UNITED STATES PATENT AND TRADEMARK OFFICE

APPLICATION NO.	FILING DATE	FIRST NAMED INVENTOR	ATTORNEY DOCKET NO.	CONFIRMATION NO.
10/734,538	12/12/2003	Chien-Kuo Chang	14104 B	9710

Office Action Summary

DETAILED ACTION

Vondrejs '977 Figure 2

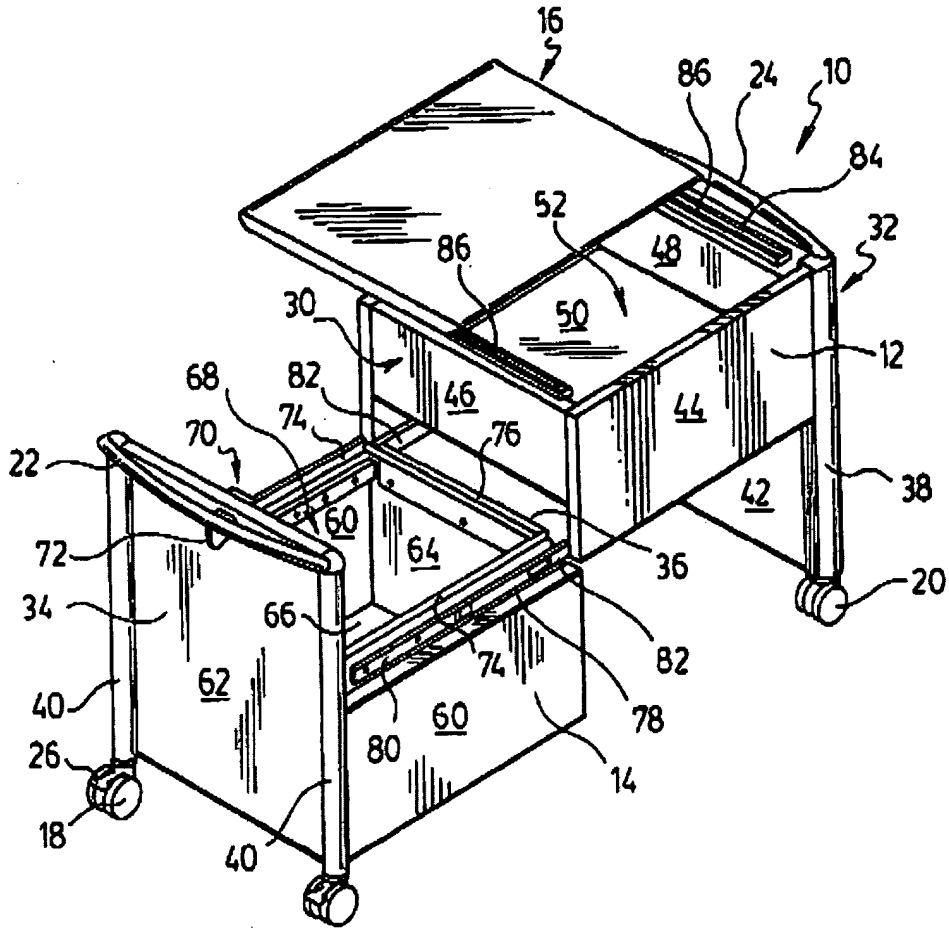
3. Claims 1 and 3 are rejected under 35 U.S.C. 103(a) as being unpatentable over U.S. Patent 6,209,977 to Vondrejs in view of U.S. Patent 5,570,792 to Huang. Vondrejs '977 discloses a mobile filing unit (10) that has a housing (12) with an open top side. A face panel (16) is connected to slides (84), which allow the face panel to open or close the opening in the top side of the housing. The slides (84) have two tracks (86) mounted inside the housing. Slide rails (second portion) are attached to the lower surface of the face panel (16) (Col. 5, line 24-27) and are movable relative to the tracks (86).

Huang '792 Figure 1

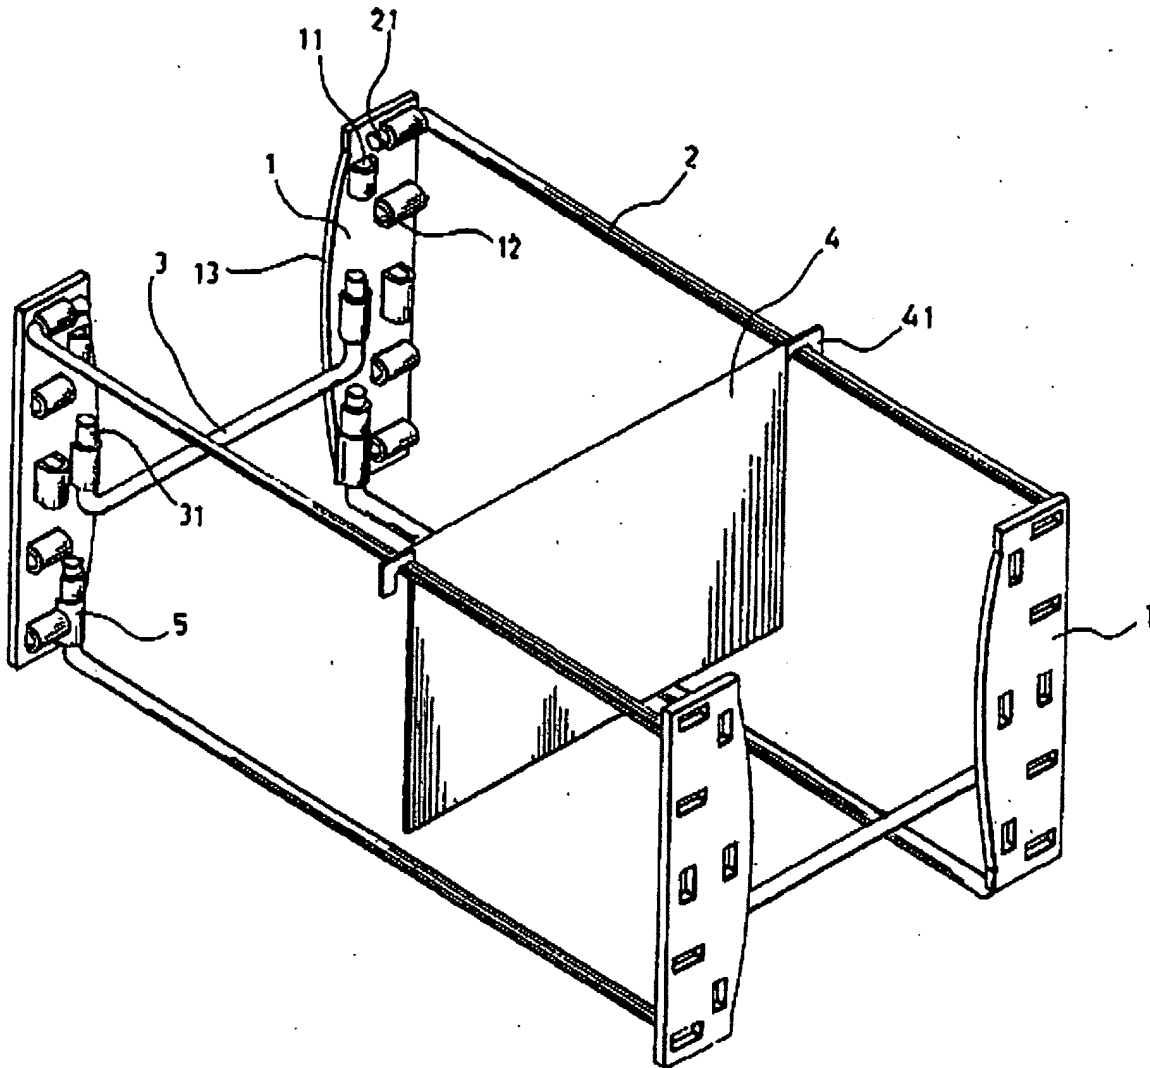
4. Vondrejs '977 does not disclose expressly a hanging rack mounted inside the housing made of rod members with mounting rings. Huang '792 discloses a hanging rack for hanging files made of two first rod members (2) in parallel with two second rod members (3) also in parallel and connected between the first rod members (2). At the distal ends (21,31) of the rod members (2,3) is a plate (1) with mounting rings (11,12), which inherently can be fastened to a housing. At the time of the invention it would have been obvious for a person skilled in the art to take the mobile filing unit of Vondrejs and

use the hanging rack of Huang since the rack of Huang can be adjusted to fit files of different sizes.

Welch '567 Figure 1

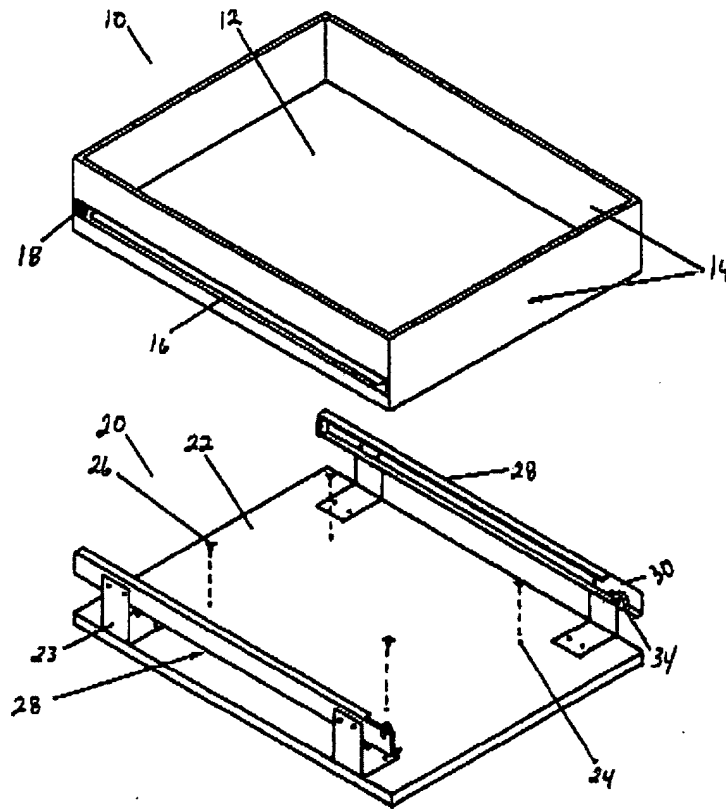
modified by Huang '792 discloses every element as discussed above. Vondrejs '977 in view of Huang '792 does not expressly disclose the sliding rails with two lugs near two distal ends and the face panel with locating blocks on the bottom side that fasten to the lugs of the sliding rail. Welch '567 discloses a drawer (10) with tracks (16). The tracks (16) slideable engage slide rails (28) that are attached via lugs (23) to a base plate (22). It is well within the ability of a person of ordinary skill in the art to flip the slide rails (28) and tracks (16) so that the base plate (22) would be on top and become a face panel (22). At the time of the invention it would have been obvious to a person of ordinary skill in the art to flip the slide rails (28) and tracks (16) so that the base plate (22) would be on top and become a face panel (22) and then to use these rails with the mobile filing unit of Vondrejs modified by Huang since Vondrejs disclosed that the face panel can be opened by any means known in the art (Col. 5, line 16-22) and the slide rail with the lugs space the face panel away from the housing.

6. It would have been obvious matter of design choice to modify Welch by having blocks as spacers and using shorter lugs of the slide rail instead of longer lugs that extend to the surface of the face panel, since the applicant has not disclosed that having blocks there solves any stated problem or is for any particular purpose and it appears that the slide rail would perform equally well with blocks and shorter lugs.

Hassel '216 Figure 1

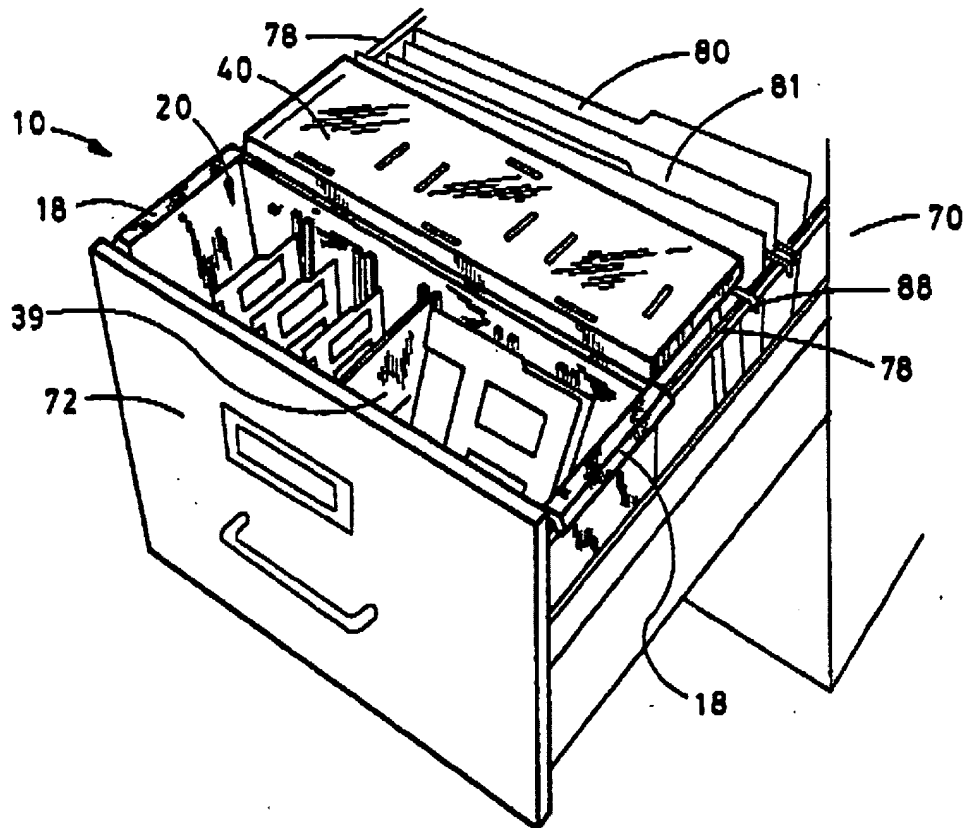
7. Claims 4-6,8, and 9 are rejected under 35 U.S.C. 103(a) as being unpatentable over U.S. Patent 6,209,977 to Vondrejs in view of U.S. Patent 5,570,792 to Huang as applied to claims 1 and 3 above, and further in view of U.S. Patent 5,219,216 to Hassel. Vondrejs '977 modified by Huang '792 discloses every element as discussed above. Vondrejs '977 in view of Huang '792 does not expressly disclose a storage box with a plurality of ribs inside and top hooks to hang from the hanging rack. Hassel '216 discloses a storage box (20) that has top hooks (18) to hang on hanging rails (78) of a housing (10). The storage box (20) has a plurality of ribs (29) disposed of on the inside,

which hold a vane (39) to divide the storage box (20) into a plurality of compartments. At the time of the invention it would have been obvious to take the mobile filing unit of Vondrejs modified by Huang and add the storage box of Hassel to hold computer disks.
